Access Compliance Report

Public Rights-of-Way (Curb Ramps)

Intersection ID: 11265	Main Street: N_TRYON_ST	Cross Street: WADSWORTH_PL	Location: W
ADA ID: 44AD77A0B634	Ramp Type: Perp	Initial Pass/Fail: Fail	Overall Compliance: No
		Severity Score: 10

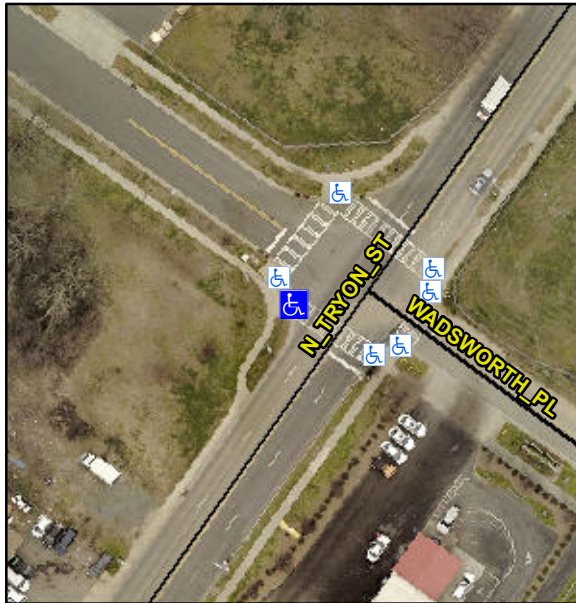
Not Found, R304.5.1, R304.5.3

Compliance	Description	Data	Compliance	Description	Data
N/A	Ramp Length (in)	95.0	Yes	Ramp Slope (%)	5.2
No	Ramp Width (in)	46.5	No	Ramp XSlope (%)	2.5
N/A	Flare Type LT	N/A	N/A	Flare Type RT	N/A
N/A	Flare Slope LT (%)	N/A	N/A	Flare Slope RT (%)	N/A
N/A	Flare Traversable LT?	N/A	N/A	Flare Traversable RT?	N/A
N/A	Landing Length (in)	N/A	N/A	DWS Provided?	N/A
N/A	Landing Width (in)	N/A	N/A	DWS Contrast?	N/A
N/A	Landing Slope (%)	N/A	N/A	DWS Length (in)	N/A
N/A	Landing X Slope (%)	N/A	N/A	DWS Full Width?	N/A
N/A	Landing Curb? (Y/N)	N/A	N/A	DWS Offset (in)	N/A
N/A	Shared Landing?	N/A			
N/A	Gutter Ponding?	N/A	N/A	Gutter Slope (%)	N/A
N/A	Gutter Lip Ht (in)	N/A	N/A	Gutter X Slope (%)	N/A
N/A	Painted X Walk1?	Yes	N/A	Painted X Walk2?	N/A
	X Walk 1 Direction	To SE		X Walk 2 Direction	N/A
N/A	X Walk 1 Width (in)	116.5	N/A	X Walk 2 Width (in)	N/A
	X Walk 1 Slope (%)	3.5		X Walk 2 Slope (%)	N/A
	X Walk 1 X Slope (%)	0.4		X Walk 2 X Slope (%)	N/A

Remove & Replace Entire Ramp.
